Urgent Field Safety Notice

Commercial name of the affected product: Aptio Automation

FSCA-identifier: FSCA – AP2 – 202303 – 03

FSN-identifier: FSN – AP2 – 202303 – 03 v.2

Image 1: Divert gate position

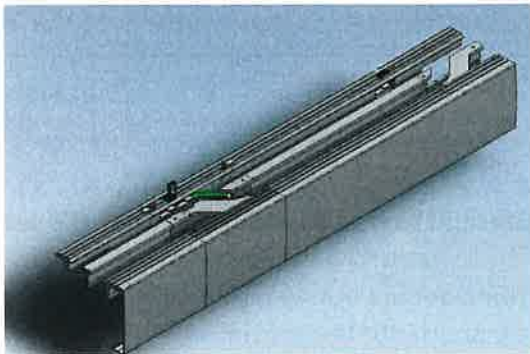
To avoid the occurrence of the described issue Inpeco recommends to visually check every day the gates at the buffer lane entry of the impacted modules (refer to Image 1) to verify that:

Image 2: Divert appearance

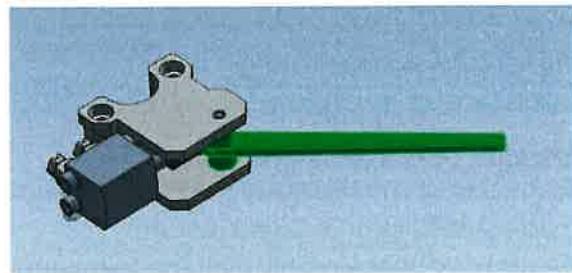
- there are no obstructions that prevent the correct activation and movement of the divert;
- the divert looks to be intact, refer to Image 2;
- the position of the divert is aligned to the profiles when it is diverting a tube, refer to Image 3; tubes that need to be routed by the module are diverted fluidly, without any missing or partial block of the carrier.
